<b>JRPP No.</b>	<b>Item 1 (2009SYW 004)</b>
<b>DA No.</b>	<b>200900288 – 359 Illawarra Road Marrickville</b>
<b>Applicant:</b>	<b>Abadeen Marrickville</b>
<b>Report By:</b>	<b>Acting Director, Development &amp; Environmental Services - Marrickville Council</b>

## **Assessment Report and Recommendation**

Application to demolish the existing improvements and erect a mixed use development containing 128 dwellings, 6,072m<sup>2</sup> of retail/commercial uses (including a supermarket with a gross floor area of 3,311m<sup>2</sup>) and a 612m<sup>2</sup> club (Marrickville RSL Club) with off street parking for 396 vehicles. Fifty-three (53) submissions and two petitions, containing a total of 362 signatures were received in response to Council's notification of the proposal.

*Image 22: City views enjoyed from 14/2-6 Schwebel Street.*

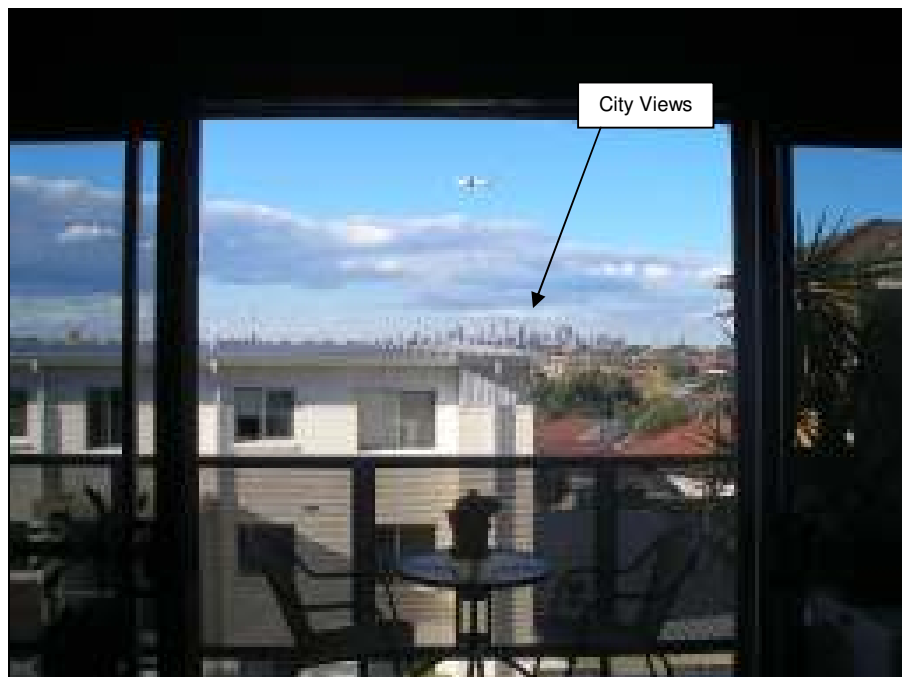
13. The carrying out of the proposed development would result in significant view loss for adjoining properties in the vicinity of Schwebel Street.
  14. The development plans accompanying the development application do not indicate the BASIX commitments as specified in BASIX Certificate Nos. 260276M and 2601150M.
